Foam Cutter Guidelines

Figure 1 - Wing tip during cutting

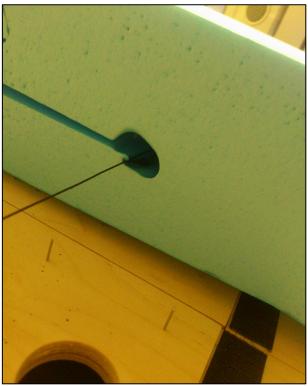
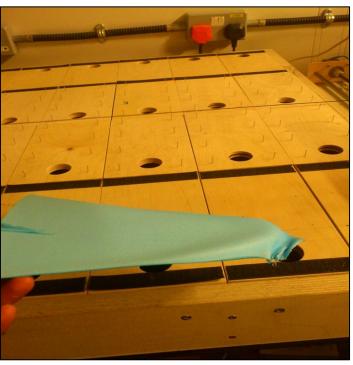
The kerf of the hot-wire cutter depends on wire speed - and a smaller tip means that the wire will move at a slower speed at the tip than at the root. Slow speeds also lead to warping of the foam. Bear this in mind if you have a small or particularly slender tip profile. I'd advise aiming for larger than the minimum stated in the brief - if your wing comes out horribly melted I'll have to replace it with something that works. Some pictures of an attempt made to cut an aerofoil with a very small tip are provided below. These pictures are an exaggeration as the tip of this particular aerofoil was extremely small. But this should give you a good idea why you should avoid very small tip profiles.

- It's difficult to determine whether an aerofoil with a small or thin tip will cut without actually doing it I'll attempt to cut anything reasonable, but if it fails then I'll have to modify your geometry if there's not an easy fix then you'll receive a standard profile. You need to balance your aerodynamic drivers with some conservativeness against manufacturing considerations.
- A couple of questions have been about issues with highly dissimilar root and tip profiles you need to have the same number of coordinates at the root as at the tip, so check this before querying further.
